### APPEAL SUMMARY

<b>Appeal ID:</b> 16170	<b>Project Address:</b> 621 SW Alder St, Unit #700
<b>Hearing Date:</b> 11/22/17	<b>Appellant Name:</b> Ivana Gazic
<b>Case No.:</b> B-008	<b>Appellant Phone:</b> 503-206-3814
<b>Appeal Type:</b> Building	<b>Plans Examiner/Inspector:</b> Steven Freeh
<b>Project Type:</b> commercial	<b>Stories:</b> 9 <b>Occupancy:</b> B <b>Construction Type:</b> I-A
<b>Building/Business Name:</b>	<b>Fire Sprinklers:</b> Yes - fully sprinklered
<b>Appeal Involves:</b> Alteration of an existing structure <b>LUR or Permit Application No.:</b> 17-254540-CO	
<b>Plan Submitted Option:</b> pdf [File 1] [File 2]	<b>Proposed use:</b> not given

**CKA OFFICE REMODEL**  
**7TH FLOOR - ELECTRIC BUILDING**

BUILDING CODE APPEAL

5  
ELEVATOR LOBBY - SECTION - ENTRANCE DOOR  
1 1/2" = 1'-0"

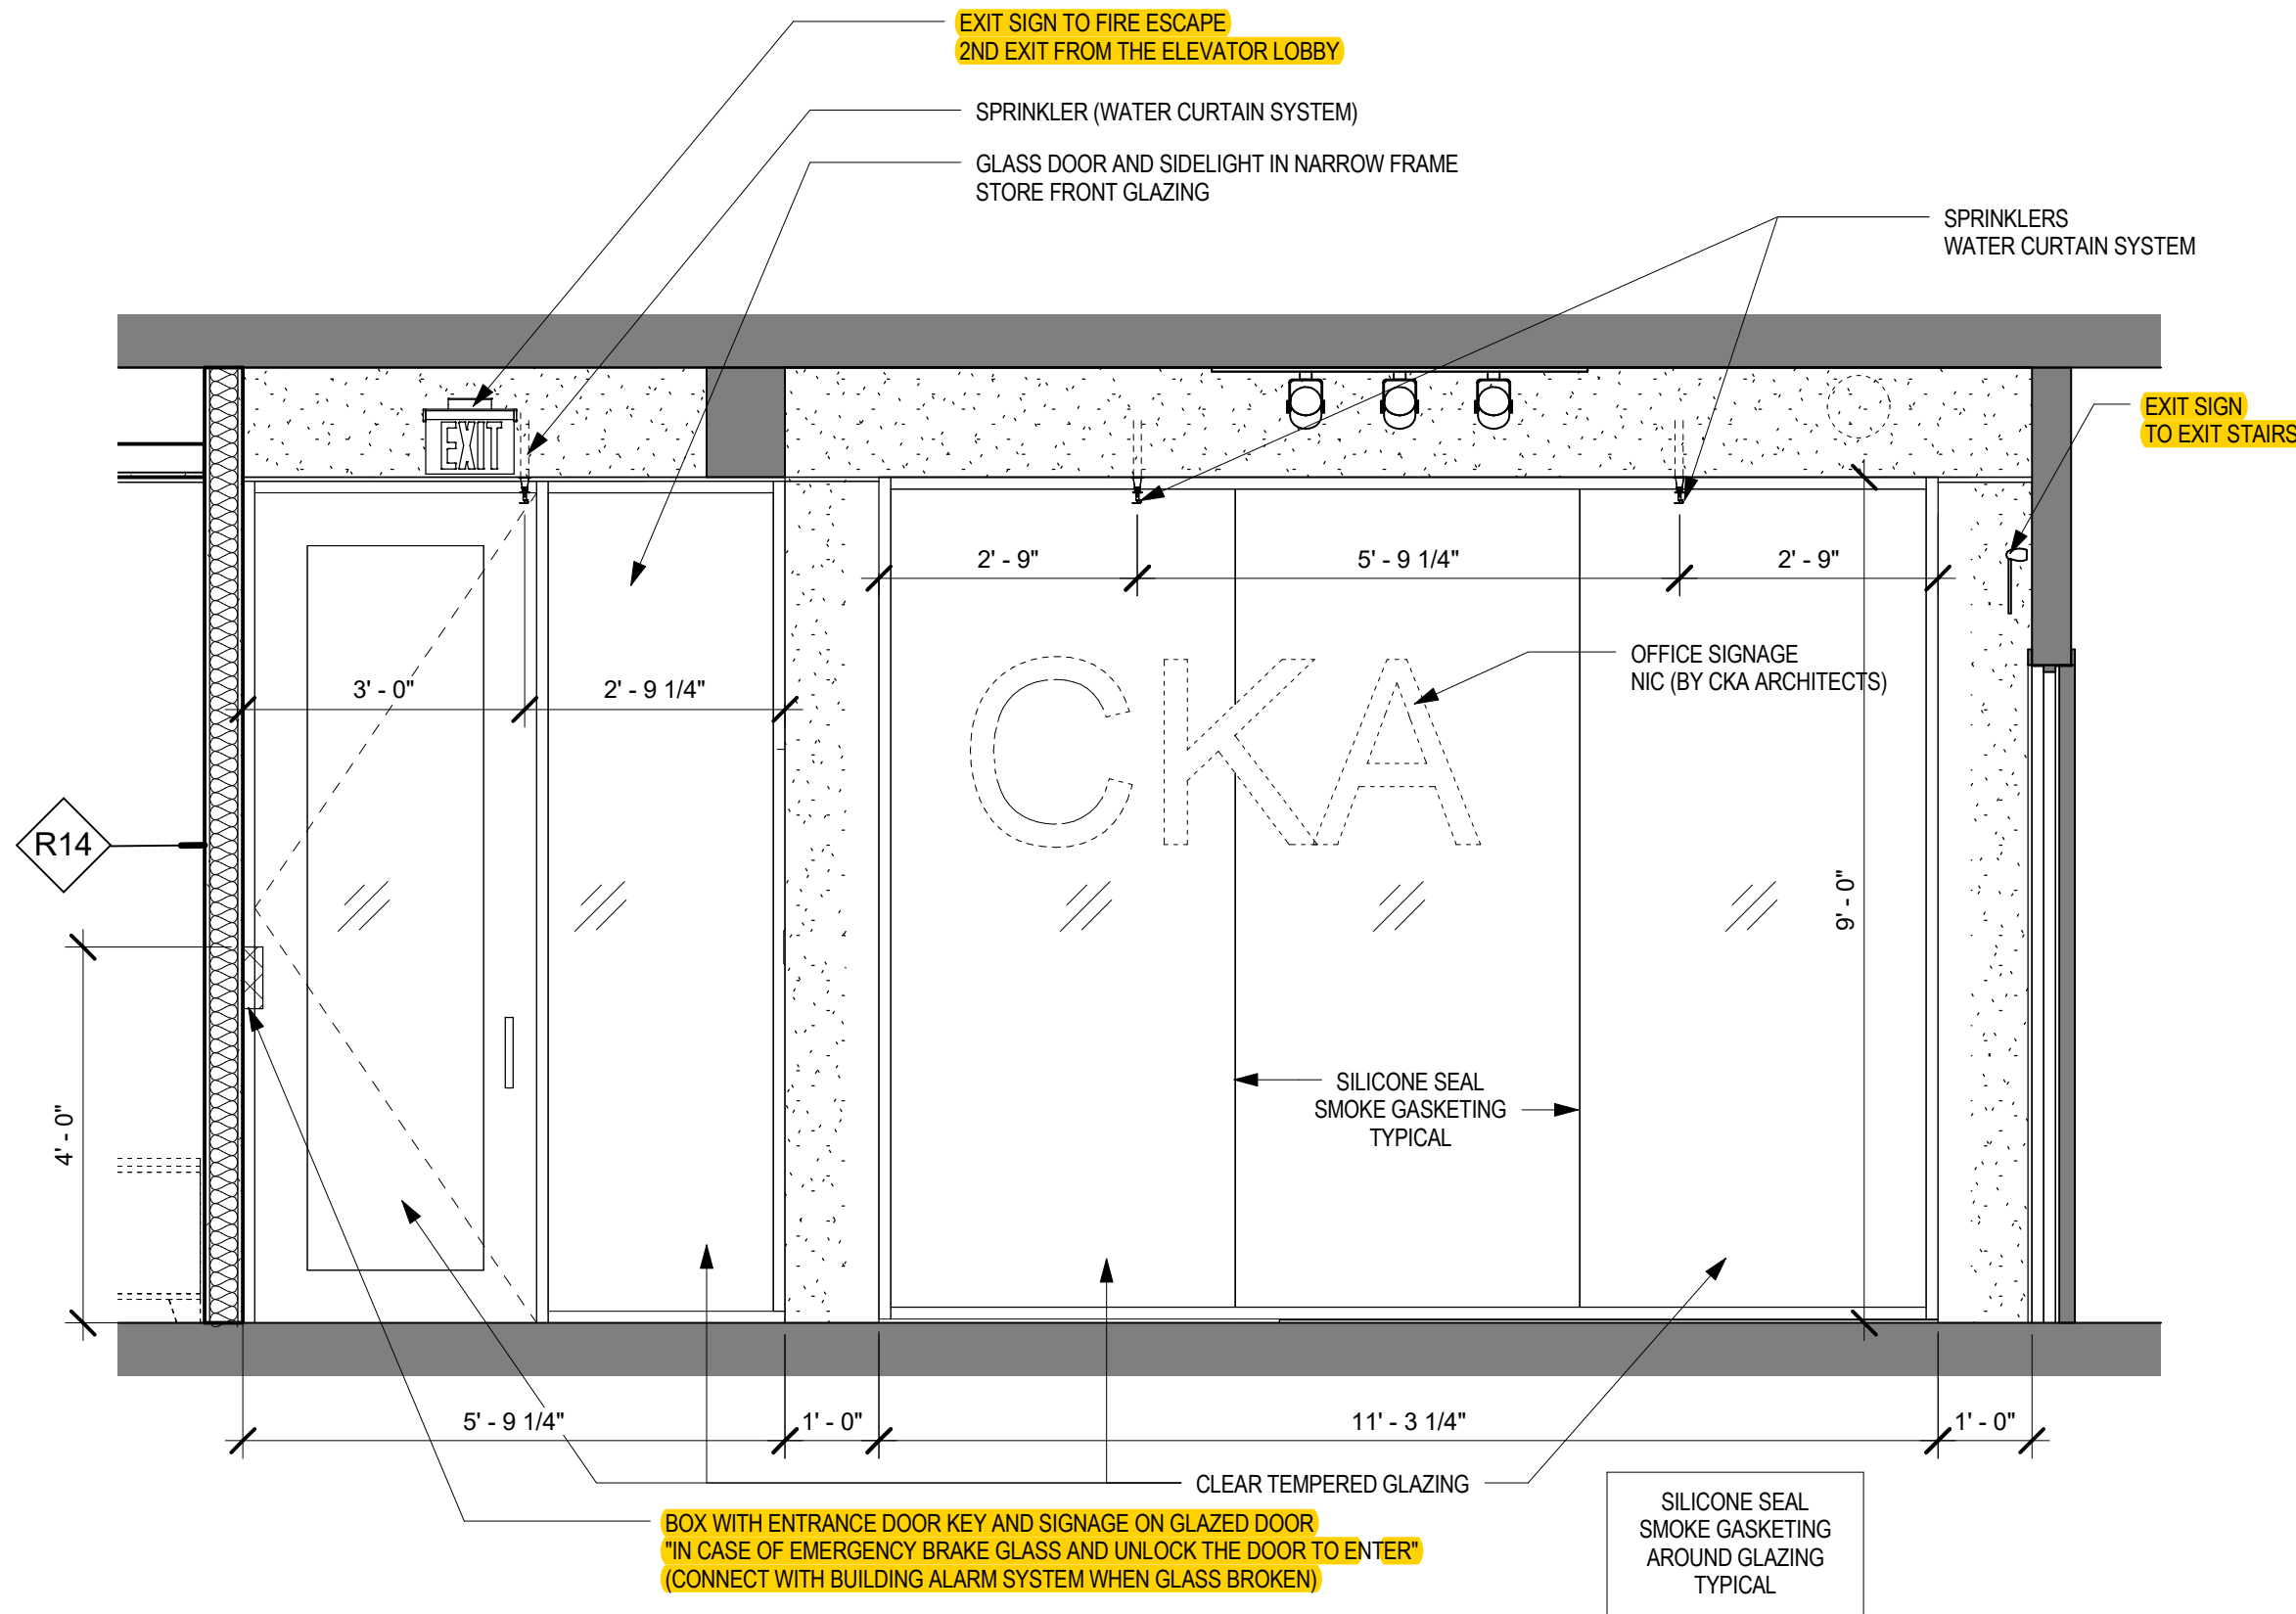
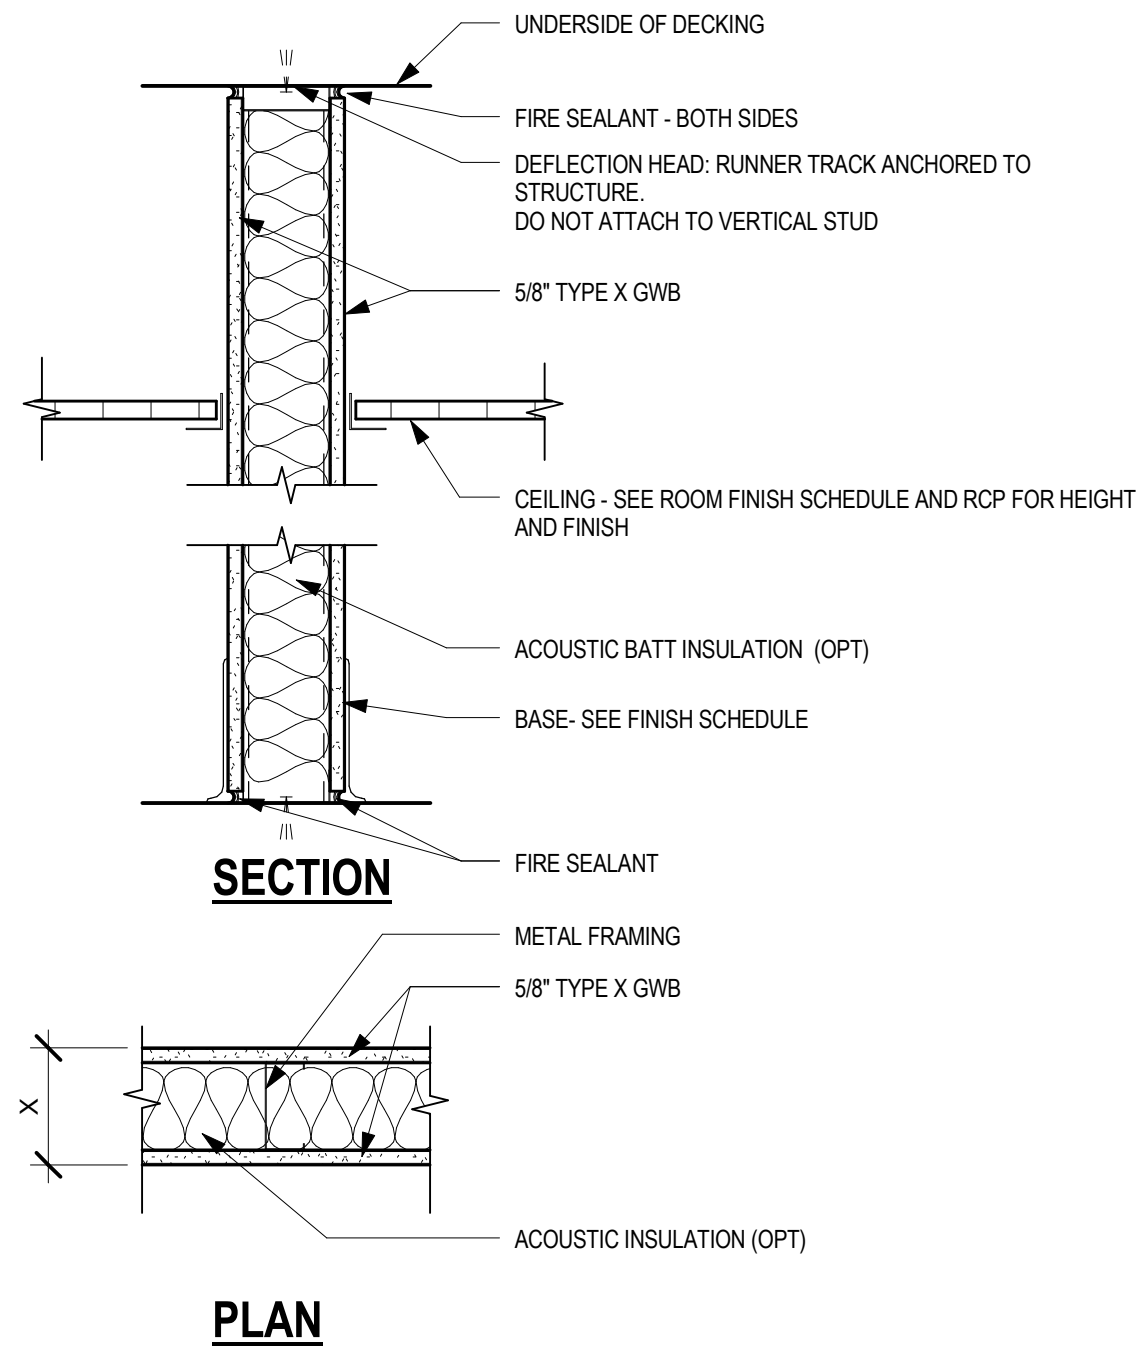
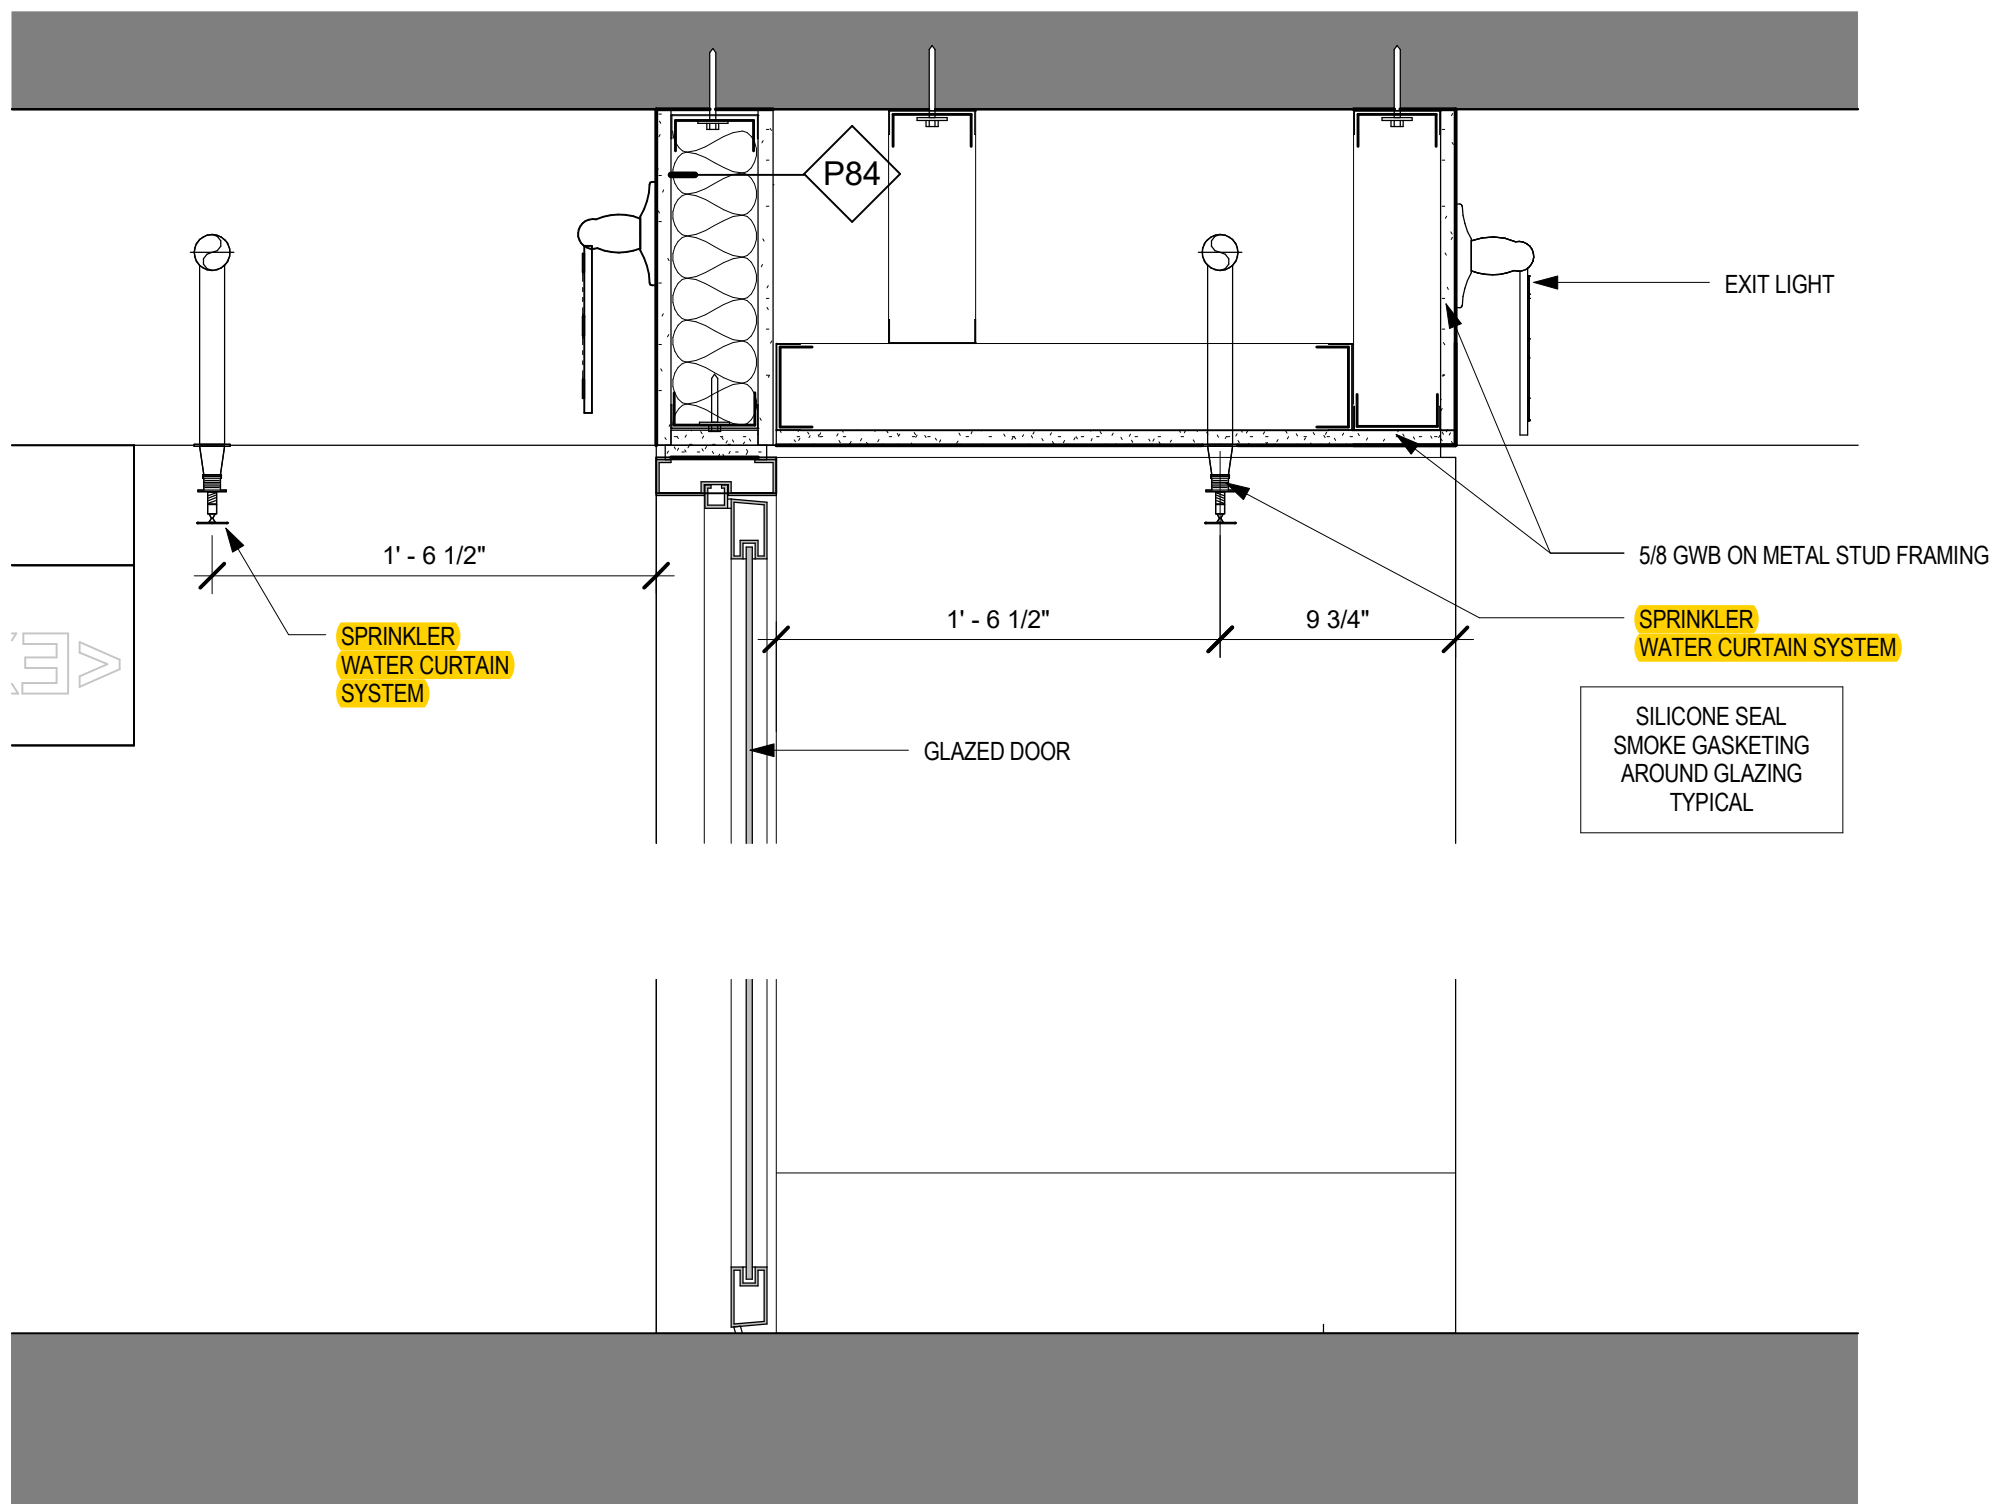
**Proposed Design** The proposed design consists of 1-HR fire rated partition walls (P84) and 1/2" tempered glass at Door # 722 and at the new windows into the office space. In place of the fire rated doors and windows, we propose a deluge sprinkler wall wash system installed to the satisfaction of the Fire Marshal's Office on either side of the glass door (#722) and the new windows (see attached plan A4.01). This "water curtain" system is described in the National Fire Protection Association (NFPA) Standard No. 13, Section 5-3.7 and 4-13.14.1 to protect proposed non-fire rated door construction in an exit-access doorway. In addition, silicone smoke gasketing will be installed on all edges of glass door and at glass panel joints.

Closely spaced, quick response sprinkler heads (@ 6' o.c. minimum) will be located at the ceiling on both sides of the door opening and the glazing and will be designed to wash glazing for maximum effect.

Water curtains are a recommended means of providing exposure protection to buildings. Reference NFPA 13 Section 3-7 and Section 5.6.

**1. Sprinkler curtain in lieu of 1 hour rated openings in elevator lobby: Granted provided sprinklers are installed per the Fire Marshal's office and are capable of wetting the entire surface. A separate permit from the Fire Marshal's Office is required.**
